**STAFF RECOMMENDATION**  
**1511 Clayton Avenue**  
**September 18, 2013**

**Application:** 1511 Clayton Avenue  
**District:** Belmont-Hillsboro Neighborhood Conservation Zoning Overlay  
**Council District:** 18  
**Map and Parcel Number:** 11708018300  
**Applicant:** Andy Beck, BB Construction  
**Project Lead:** Melissa Baldock, melissa.baldock@nashville.gov

<p><b>Description of Project:</b> The applicant is proposing to construct a new two-story primary building to replace a non-contributing building.</p> <p><b>Recommendation Summary:</b> Staff recommends approval of the project with the following conditions:</p> <ol style="list-style-type: none"> <li>1. The applicant submit revised elevation drawings that show the site's slope and the true height of the foundation and building;</li> <li>2. The depth of the front balcony be reduced by two feet (2');</li> <li>3. Staff review the window and door specifications, asphalt shingle color, and materials for the porch floor, porch railing, and porch columns;</li> <li>4. The front dormer be inset a minimum of two feet (2') from the wall below;</li> <li>5. All double and triple windows have a four to six inch (4"-6") mullion in betwe

# SITE PLAN

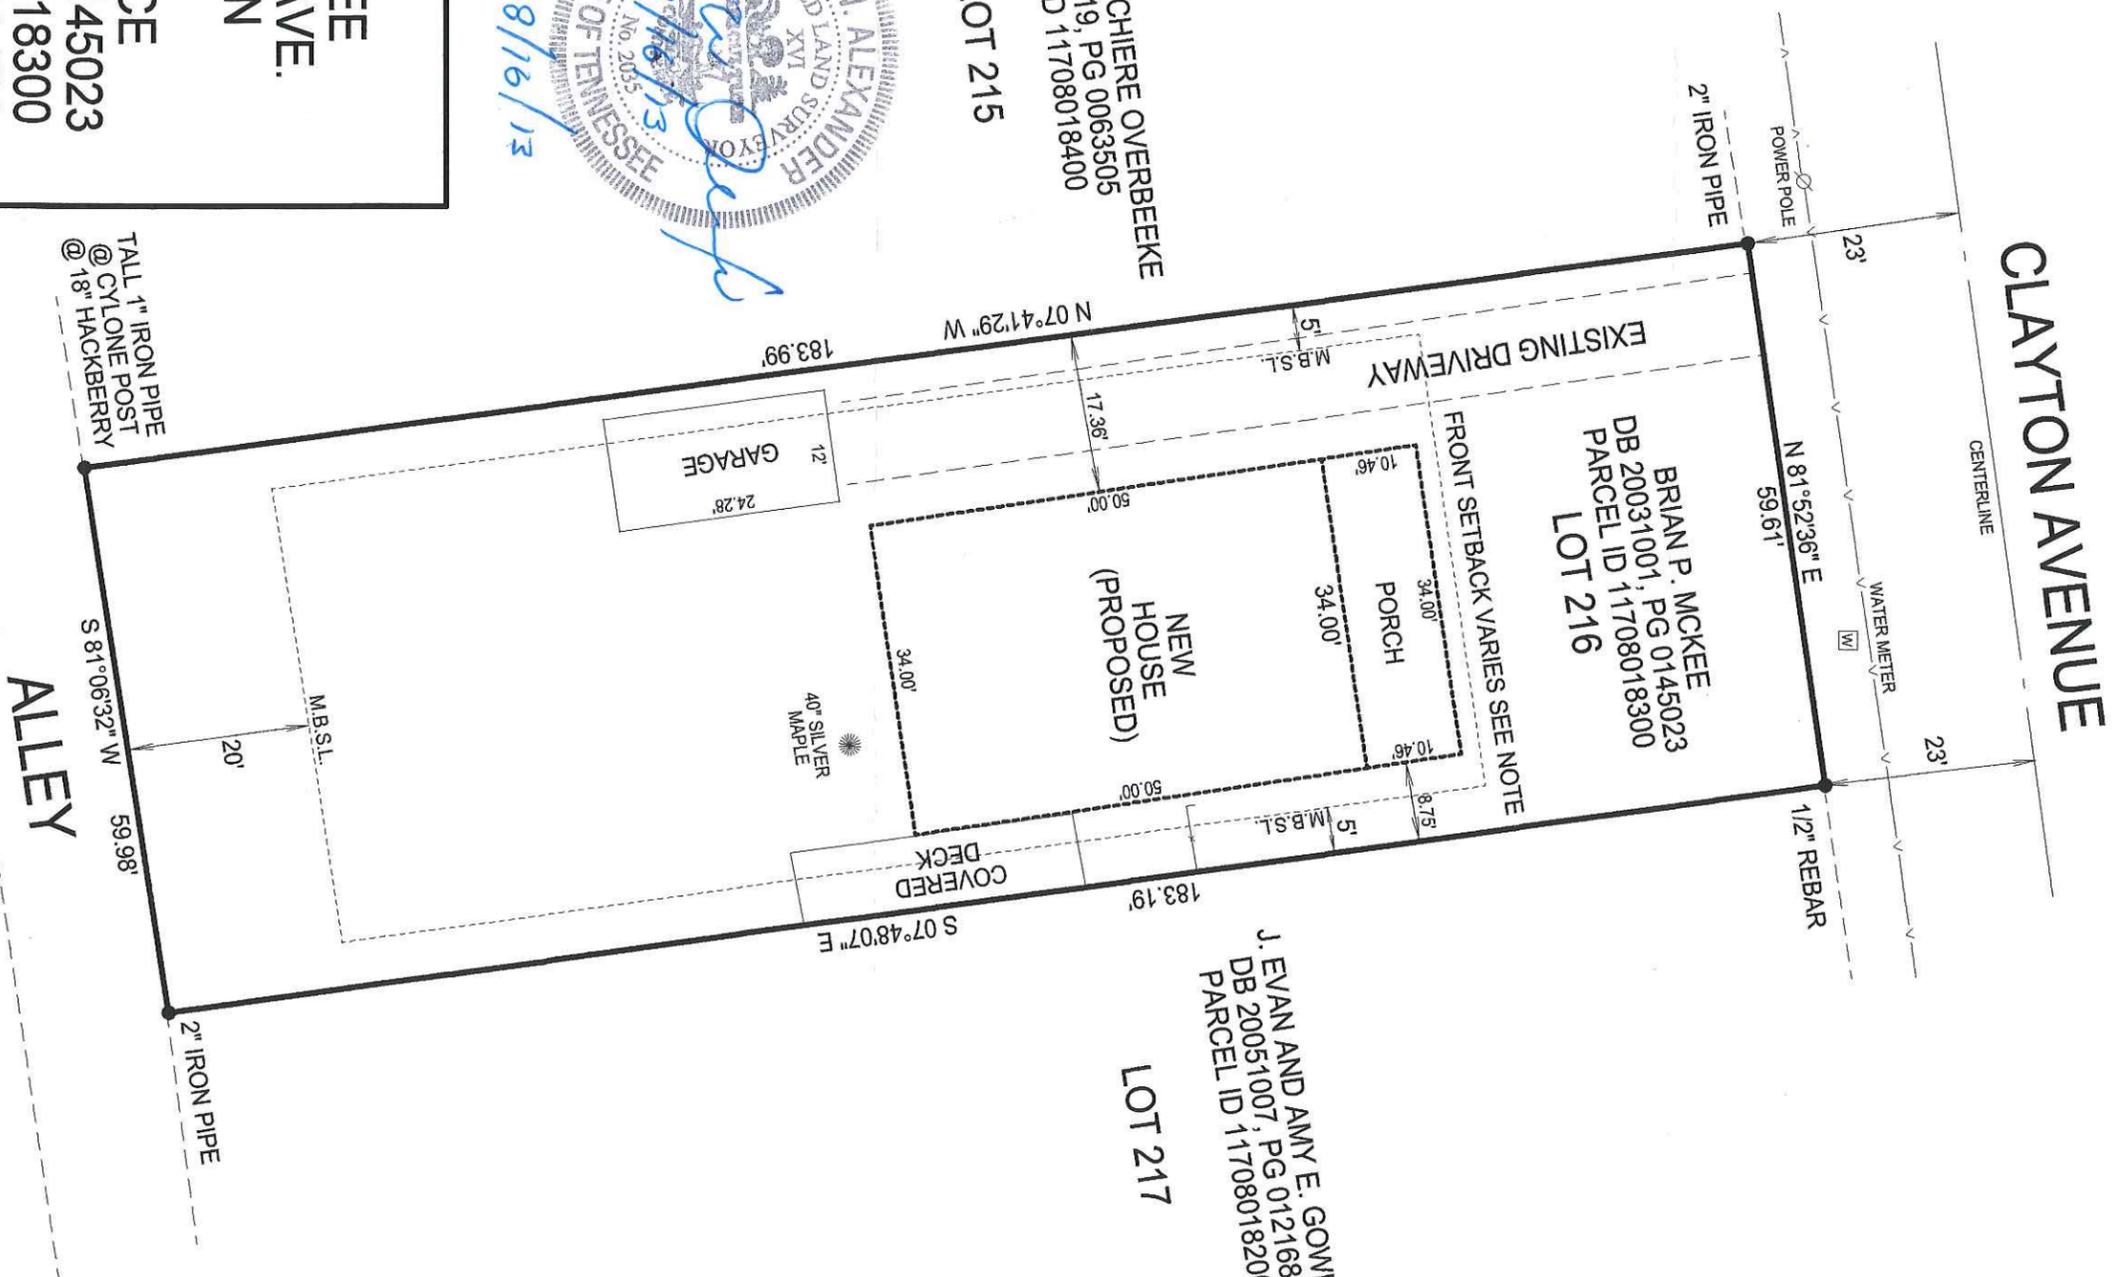
**Setbacks, Orientation:** The new infill is oriented to face Clayton Avenue. It has a full-width front porch that is over ten feet (10') deep, and has a central doorway. The new infill will meet all base zoning requirements for setbacks. It will be a minimum of eight feet (8') from the east side property line, a minimum of seventeen feet (17') from the west side property line, and over eighty-five feet (85') from the rear property line. The site plan indicates that the new infill will have a front setback similar to the existing structure, which is appropriate. The site plan also shows that an existing covered deck that abuts the side property line, and therefore does not meet the base zoning requirement for the side setback, will remain (Figure 2). Staff notes that if the covered deck is removed and reconstructed, the applicant must come to the Commission for approval of the reconstruction and setback reduction.

Public Spaces. The site plan indicates that the applicant plans to retain the existing driveway (Figure 5). Staff asks to approve all other appurtenances, including walkways and fences, prior to their installation.

PROJECT DESCRIPTION:  
**Front and Rear Elevations**  
**Brian and Rachele McKee - New House**  
 1511 Clayton Ave. Nashville, TN 37212

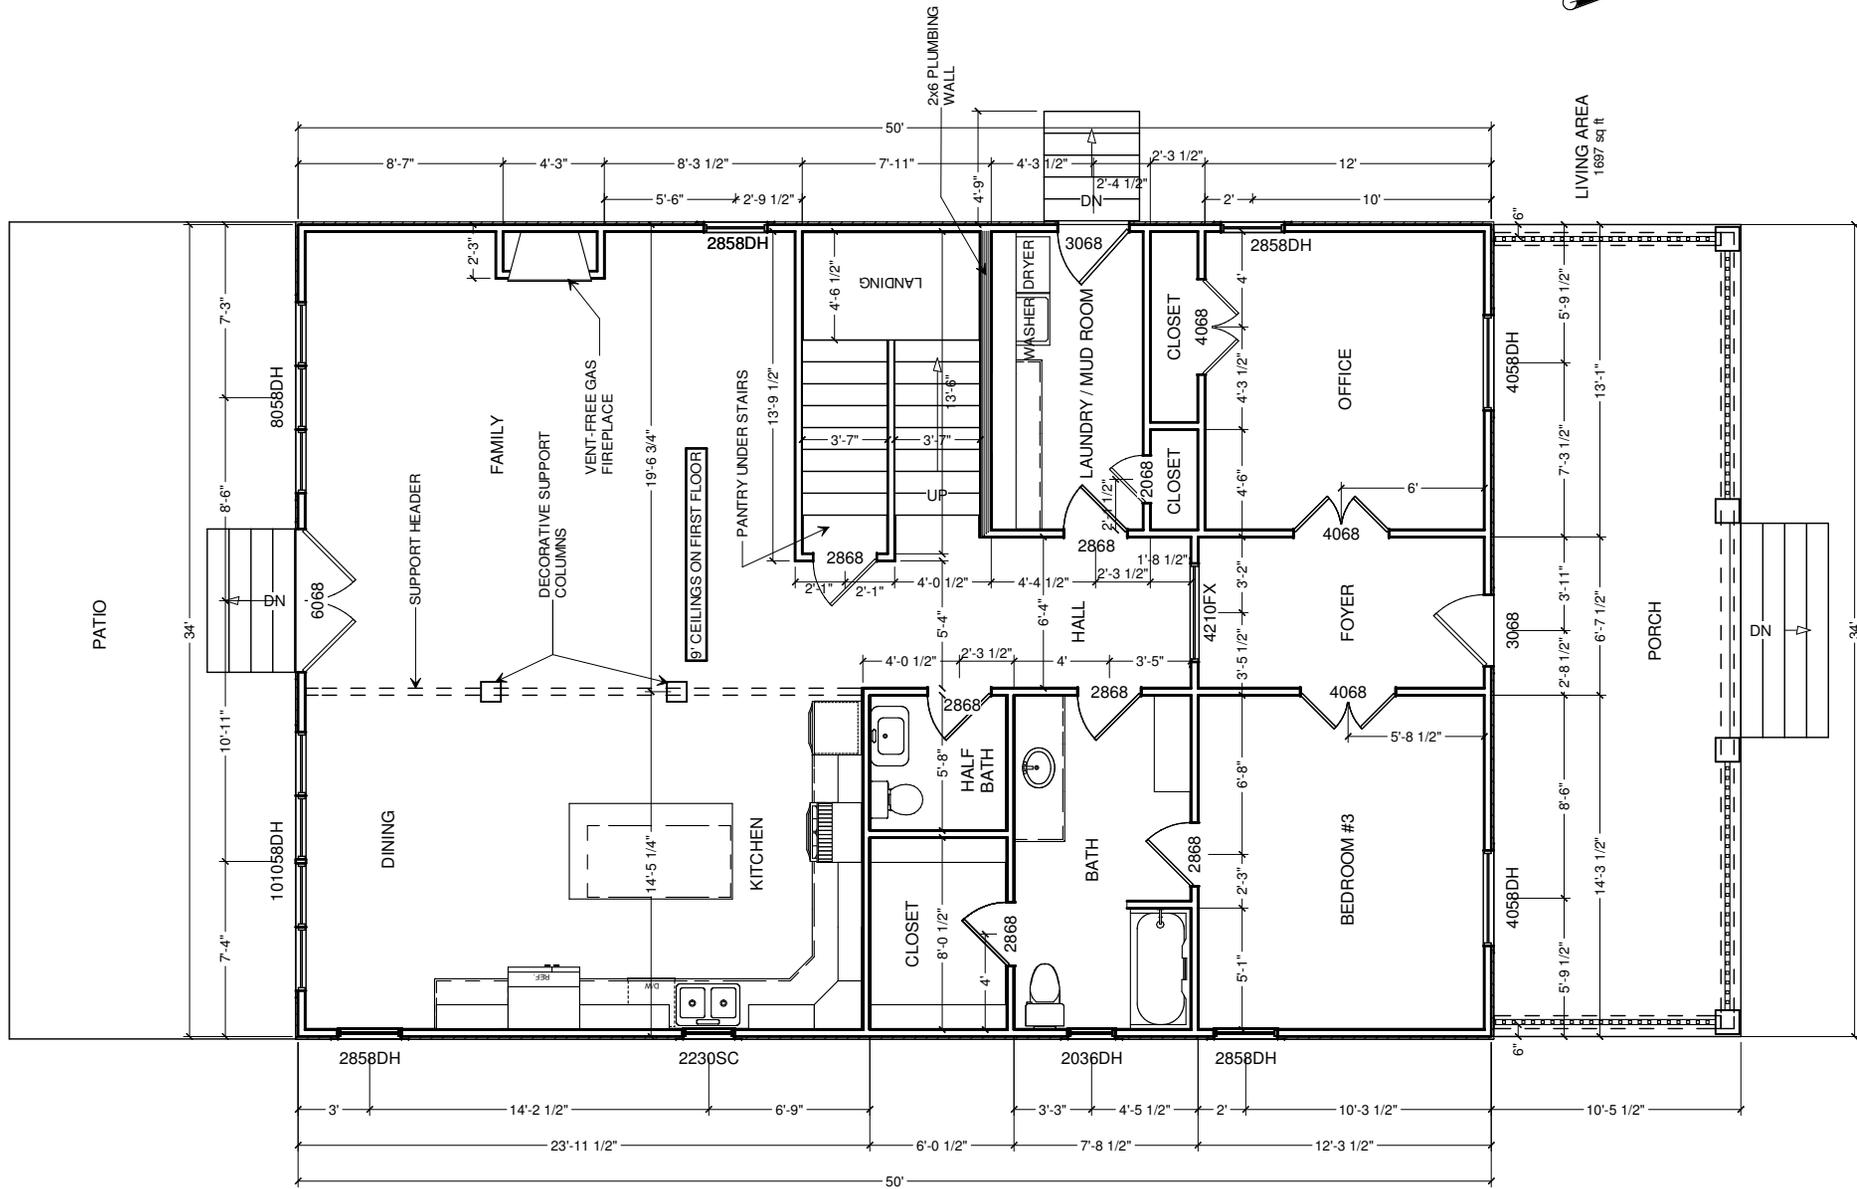
The eave height is approximately twenty feet (20') above grade, and the porch eave height is approximately eleven feet (11') above grade. The foundation height is shown to be approximately two and a half blocks, or two feet (2'), in height. The elevation drawings show the lot as flat, but the lot in fact slopes up towards the back of the lot. Staff asks that revised drawings be submitted showing the slope of the site and the relative foundation height in order to ensure that the foundation height at the front and the overall height of the building is appropriate.

The house is approximately thirty-two feet (32') wide. Staff finds that this meets the immediate historic context where most of the historic houses are between thirty and forty-eight feet (30-48') wide. The front elevation includes a centered front balcony that extends over the porch roof. The balcony is ten feet (10') wide and eight feet (8') deep, which is larger than typical second story balconies. Staff asks that a condition of approval be that the depth of the balcony be reduced by two feet (2') so that it only extends six feet (6') over the porch roof.

Roofs: The primary roof form will be a hipped roof with a slope of 6/12. Staff finds that this primary roof form is compatible with the roof forms of the Belmont-Hillsboro Neighborhood Conservation Zoning Overlay. The front façade contains a dormer with a hipped roof with a 6/12 slope. Staff asks that the dormer be pushed back so that it is inset a minimum of two feet (2') from the wall below. The front porch will have a hipped roof with a 3/12 slope, and the overhang on the right/east façade will have a hipped roof with a 6/12 slope. With the changes to the dormer, staff finds that the infill's roof forms meet Section II.B.1.e. of the design guidelines.

Proportion & Rhythm of Openings: The primary windows are generally twice as tall as they are wide, thereby meeting typical window proportions. There are no large expanses of wall space without a window or door opening. Staff asks that a condition of approval be that all double, triple, and quadruple window openings have a four to six inch (4"-6") mullion in between them. With this condition, staff finds that the infill's proportion and rhythm of openings meet Section II.B.1.g. of the design guidelines.

1. The applicant submit revised elevation drawings that show the site's slope and the true height of the foundation and building;
2. The depth of the front balcony be reduced by two feet (2');
3. Staff review the window and door specifications, asphalt shingle color, and materials for the porch floor, porch railing, and porch columns;
4. The front dormer be inset a minimum of two feet (2') from the wall below;
5. All double and triple windows have a four to six inch (4"-6") mullion in between them;
6. The HVAC and other utilities be place on the rear façade, or on the side, beyond the midpoint of the house.
7. Staff approve all new appurtenances, including fencing and walkways.
